SERVICE BULLETIN REVISION TRANSMITTAL SHEET

TITLE: AIR CONDITIONING - GENERAL - REPLACE NSA8206 SEALS BY ABS5800 PTFE SEALS IN

This page transmits Revision No. 01 of Service Bulletin No. A320-21-1165

DATE: Mar 14/07 SERVICE BULLETIN No.: A320-21-1165

Figure 1, Sheet 2 Config. 01 thru 17: Replacement of the seals of the valves (8HB),(11HB),(18HM) and (19HM)

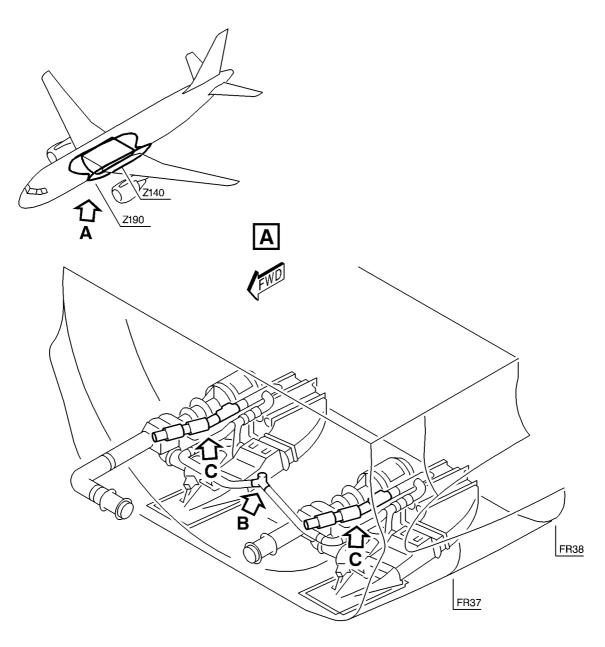
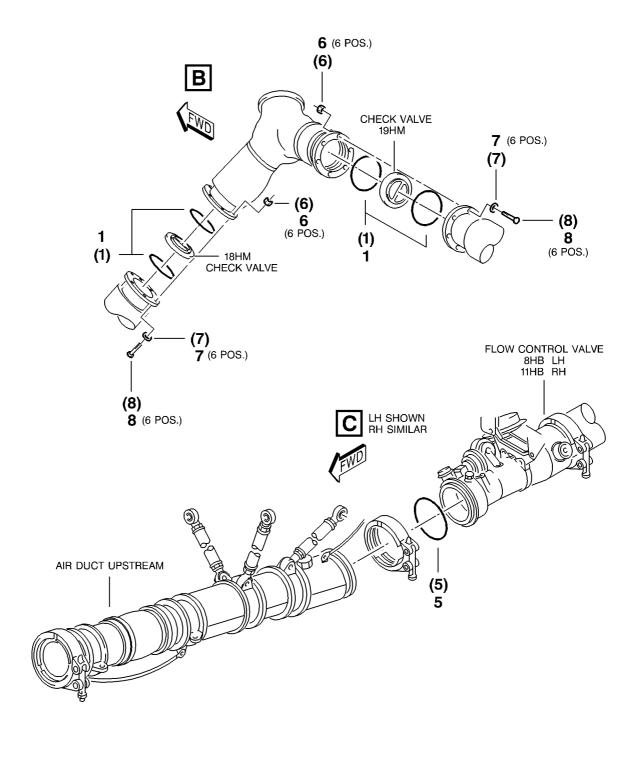
- (1) Config. 01 Config. 03
 - (a) Replace the seal of the air duct upstream of the flow control valves (8HB) and (11HB). Refer to Kit 211165D01R01

- 1 Remove, as given in AMM 21-51-51, Page block 401 and as shown on Figure 1, Sheet 2, Detail C:
 - 2 Packing-Preformed NSA8206-243 Item (5) Discard
- Install, as given in AMM 21-51-51, Page block 401 and as shown on Figure 1, Sheet 2, Detail C:
 - 2 seal ABS5800G064A Item 5
- (b) Replace the seal of the trim air check valves (18HM) and (19HM).

Remove, as given in AMM 21-63-42, Page block 401 and as shown on Figure 1, Sheet 2, Detail B:

Install, as given in AMM 21-63-42, Page block 401 and as shown on Figure 1, Sheet 2, Detail B:

Figure 2, Sheet 2
Config. 01 thru 04, 06 thru 07, 10 thru 11, 14 thru 15: Replacement of seals of the valves (11HK),(12HK),(13HK),(14HK) and of the blanking cap at the flange

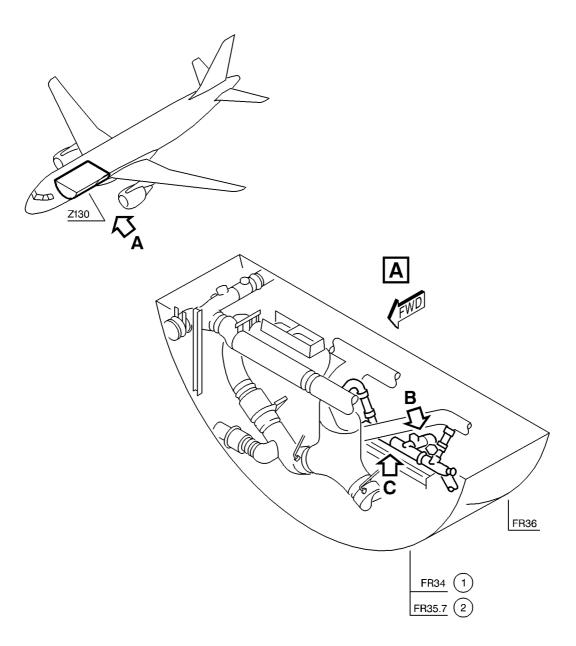
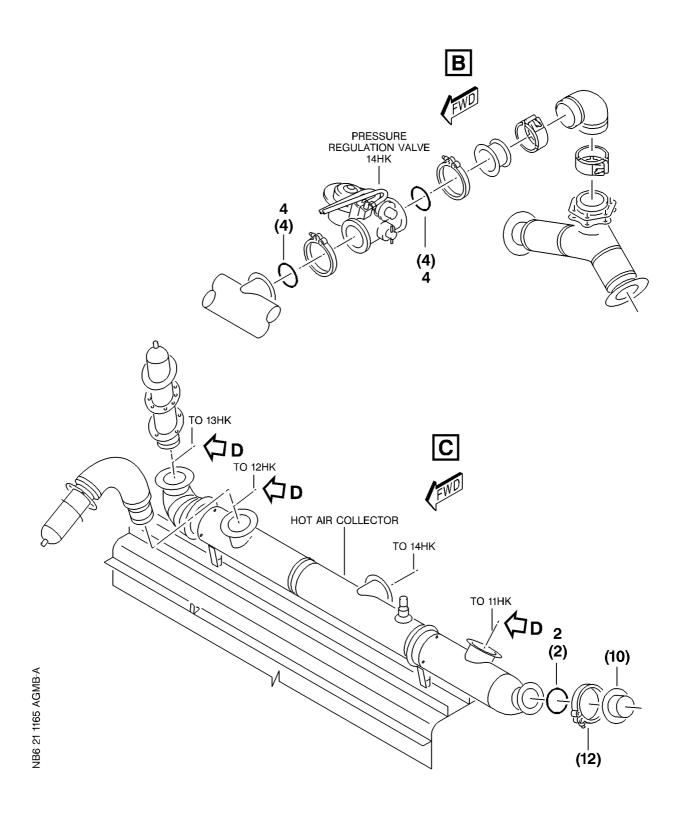
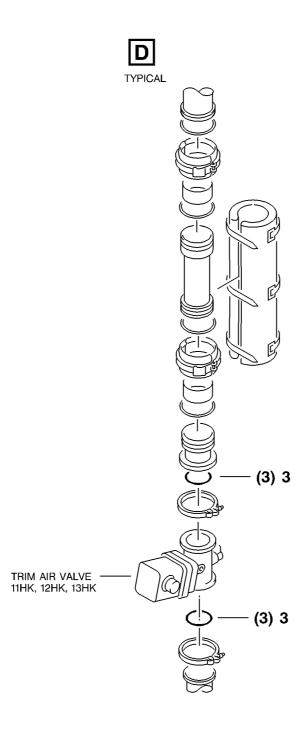
12	nut	MS21043-3	Item 6	
(c)	Refer to I Refer to I	the seal of the pressure r Kit 211165D01R01 Figure 2 AMM 21-63-52	egulating valve (14HK)).	
		ove, as given in AMM 21- neet 2, Detail B:	-63-52, Page block 401	and as show	n on Figure
	2	Packing-Preformed	NSA8206-236	Item (4)	Discard
	_	ll, as given in AMM 21-63 neet 2, Detail B:	3-52, Page block 401 a	nd as shown o	on Figure
	2	seal	ABS5800D048A	Item 4

(d)	Refer to I Refer to I	the seal of the trim air va Kit 211165D01R01 Figure 2 AMM 21-63-51	lves (11HK), (12HK) ar	nd (13HK).	
		ove, as given in AMM 21- et 2, Detail C and 3, Deta		and as showr	n on Figure 2,
	6	Packing-Preformed	NSA8206-228	Item (3)	Discard
		ll, as given in AMM 21-63 et 2, Detail C and 3, Deta		nd as shown o	on Figure 2,
	6	seal	ABS5800D032A	Item 3

(e)	•	the seal of the blanking c Kit 211165D01R01 Figure 2	ap at the flange of the	hot air collecto	or.
	<u>1</u> Rem	ove, as shown on Figure	2, Sheet 2, Detail C:		
	1 1 1	clamp flange Packing-Preformed	NSA8206-226	Item (12) Item (10) Item (2)	Retain Retain Discard
	2 Insta	ll, as shown on Figure 2,	Sheet 2, Detail C:		
	1 1 1	seal flange clamp	ABS5800D028A	Item 2 Item (10) Item (12)	Retained Retained

Figure 3, Sheet 2
Config. 05, 08 thru 09, 12 thru 13, 16 thru 17: Replacement of the seals of the valves (11HK),(12HK),(13HK) and (14HK)

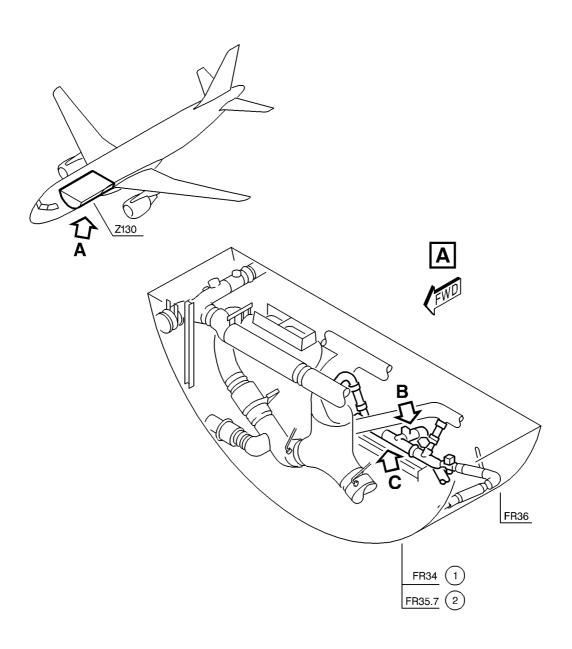
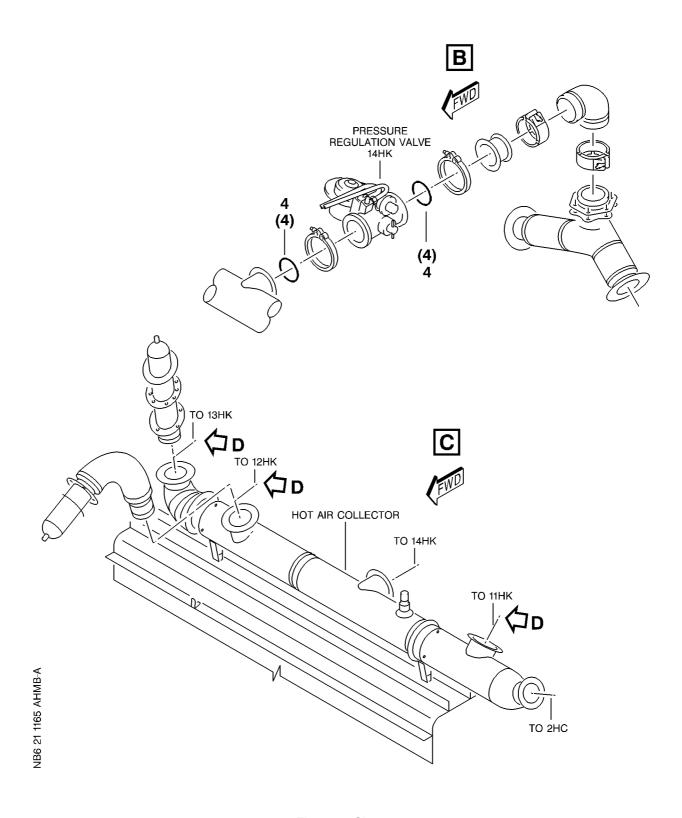
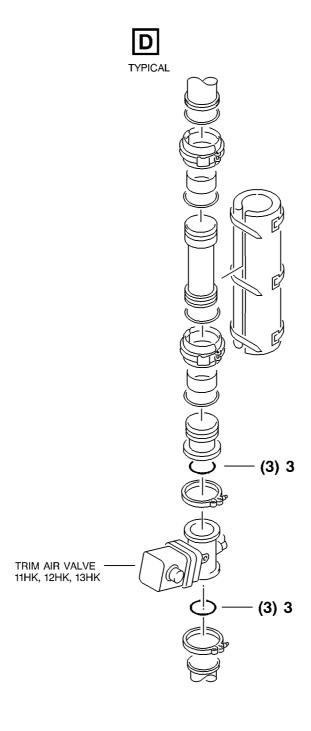
Refer to Figure 3

Remove, as given in AMM 21-63-52, Page block 401 and as shown on Figure 3, Sheet 2, Detail B:

Install, as given in AMM 21-63-52, Page block 401 and as shown on Figure 3, Sheet 2, Detail B:

Figure 4, Sheet 2
Config. 01, 03, 05 thru 06, 08, 10, 12, 14, 16: Replacement of the seal of the blanking cap at the flange of the APU bleed air duct

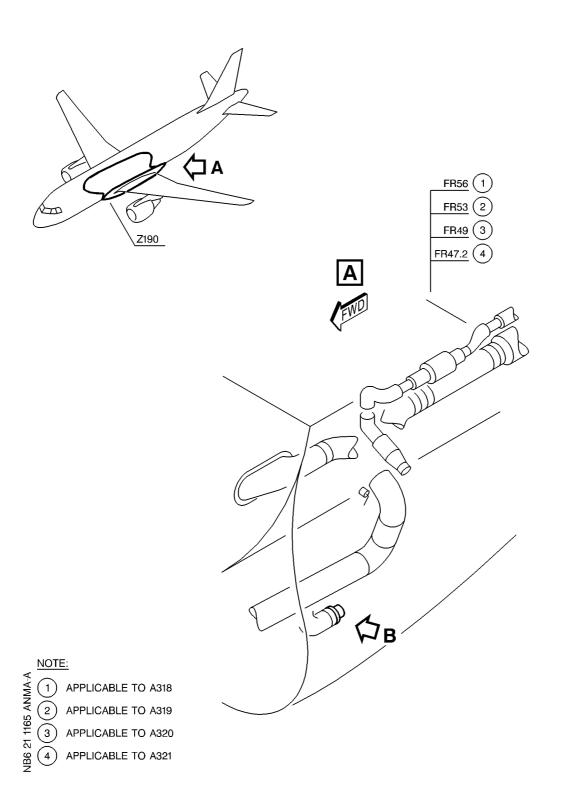
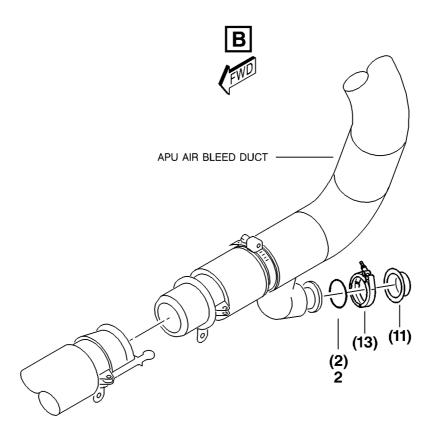
(f)	•	the seal of the blanking c Kit 211165D01R01 Figure 4	ap at the flange of the	APU bleed air	duct.

1 Remove, and as shown on Figure 4, Sheet 2, Detail B:

2 Install, as shown on Figure 4, Sheet 2, Detail B:

Figure 5, Sheet 2 Config. 02, 04, 07, 09, 11, 13, 15, 17: Replacement of the seals of the valves (11HC) and (12HC)

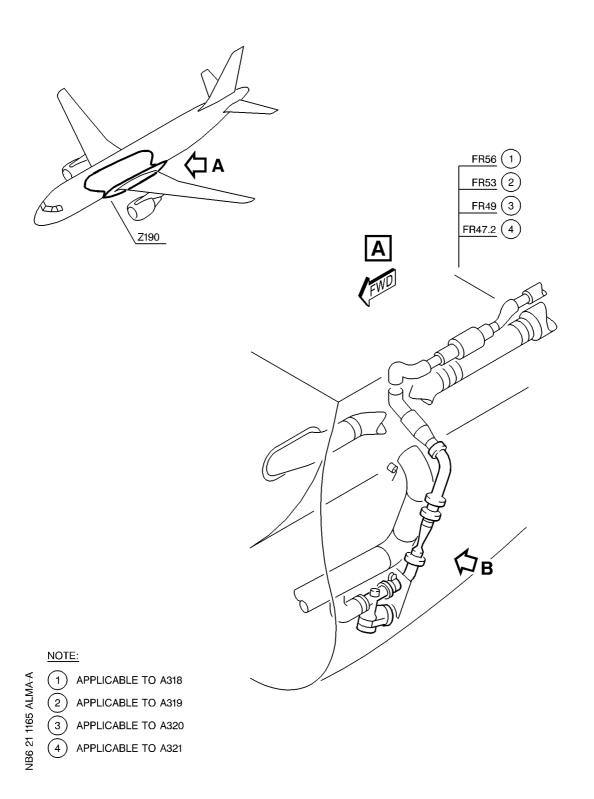
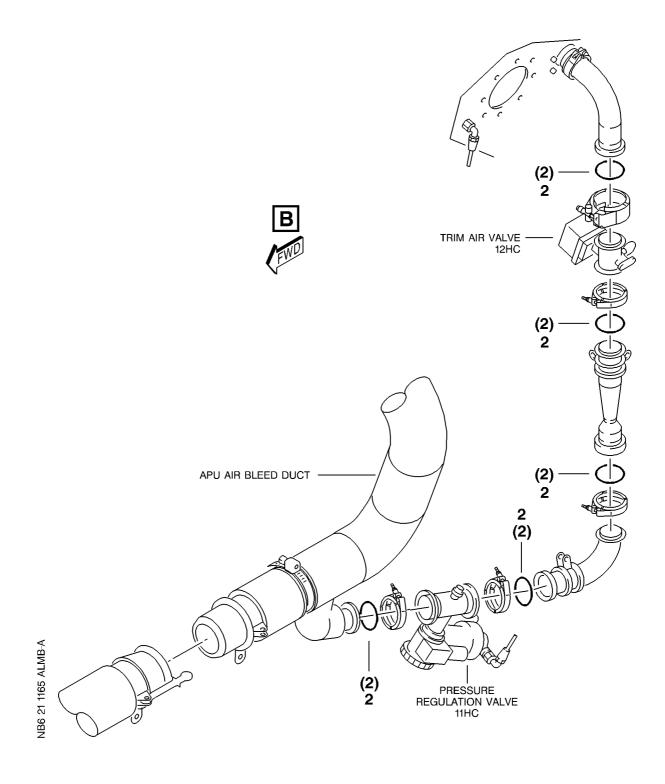
(f)	Refer to Refer to	the seal of the AFT cargo Kit 211165D02R00 Figure 5 AMM 21-43-51	o compartment trim air	valve (12HC).	
		nove, as given in AMM 21 heet 2, Detail B:	-43-51, Page block 40 ⁻	1 and as show	n on Figure

2 Install, as given in AMM 21-43-51, Page block 401 and as shown on Figure

Figure 6, Sheet 1 Config. 05, 08 thru 09, 12 thru 13, 16 thru 17: Replacement of the seals of the valve (2HC)

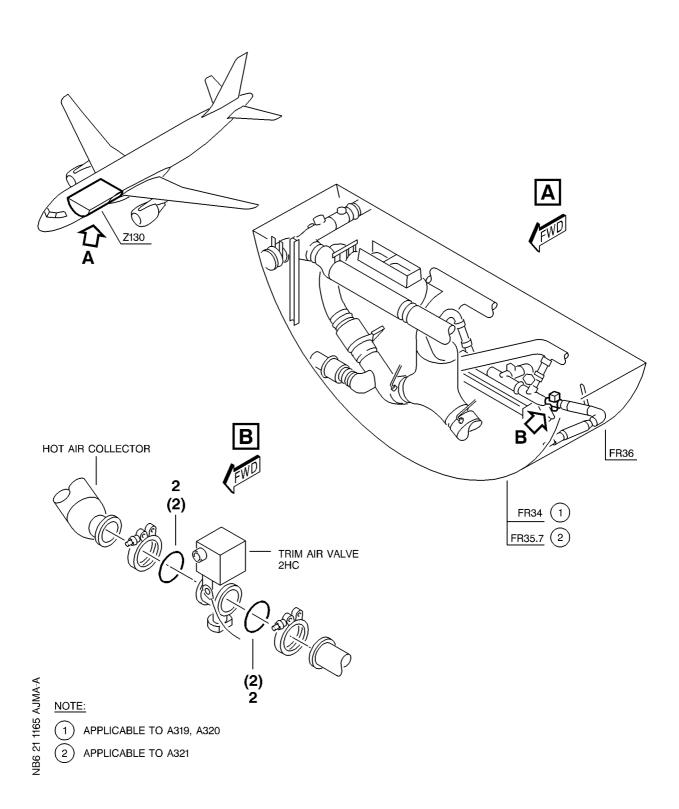
(f)	Refer to Refer to F	the seals of the FWD care Kit 211165D03R00 Figure 6 AMM 21-43-53	go compartment trim a	ir valve (2HC).

1 Remove, as given in AMM 21-43-53, Page block 401 and as shown on Figure 6, Sheet 1, Detail B:

Install, as given in AMM 21-43-53, Page block 401 and as shown on Figure 6, Sheet 1, Detail B:

Figure 7, Sheet 1
Config. 06 thru 17: Replacement of the seal of the pipe assembly

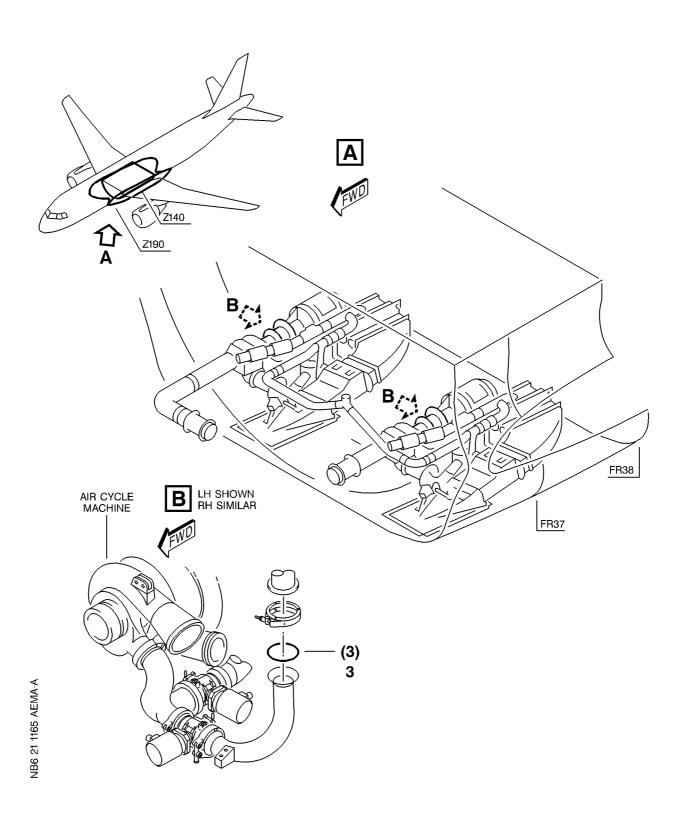
Refer to Figure 7

- Remove, as given in AMM 21-52-23, Page block 401 and as shown on Figure 7, Sheet 1, Detail B:
 - 2 Packing-Preformed NSA8206-228 Item (3) Discard
- Install, as given in AMM 21-52-23, Page block 401 and as shown on Figure 7, Sheet 1, Detail B:
 - 2 seal ABS5800D032A Item 3
